Product Change Notice (PCN)

PCN Number: **PCN-0456171R-01**

Product(s) Affected: **PJ-031DH**

PREVIOUS CUI DEVICES DETAIL / IMAGE	NEW CUI DEVICES DETAIL / IMAGE

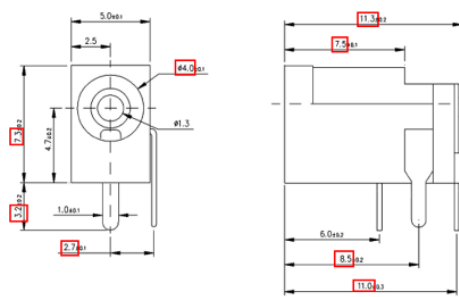
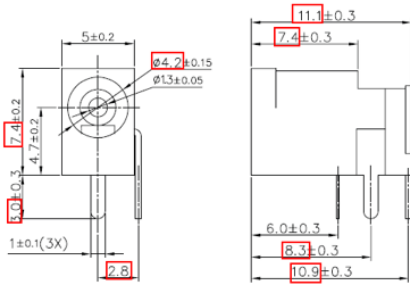
Description of Change: **Product re-engineered for improved manufacturability and production yield. See image below for product changes. Cosmetic differences may be visible and not affect the form fit and function of the product.**

PREVIOUS CUI DEVICES DETAIL / IMAGE			NEW CUI DEVICES DETAIL / IMAGE		
DESCRIPTION	MATERIAL	PLATING/COLOR	DESCRIPTION	MATERIAL	PLATING/COLOR
center pin	brass	silver	center pin	brass	CuSn
terminal 1	brass t=0.50	silver	terminal 1	brass t=0.40	silver
terminal 2	MM alloy t=0.20	silver	terminal 2	stainless steel t=0.20	silver
terminal 3	brass t=0.50	silver	terminal 3	brass t=0.40	silver
housing	PA10T (UL94V-0)	black	housing	PA10T (UL94V-0)	black

MATING PLUG	
Jack Insertion Depth: 7.0 mm

MATING PLUG	
Jack Insertion Depth: 6.2 mm
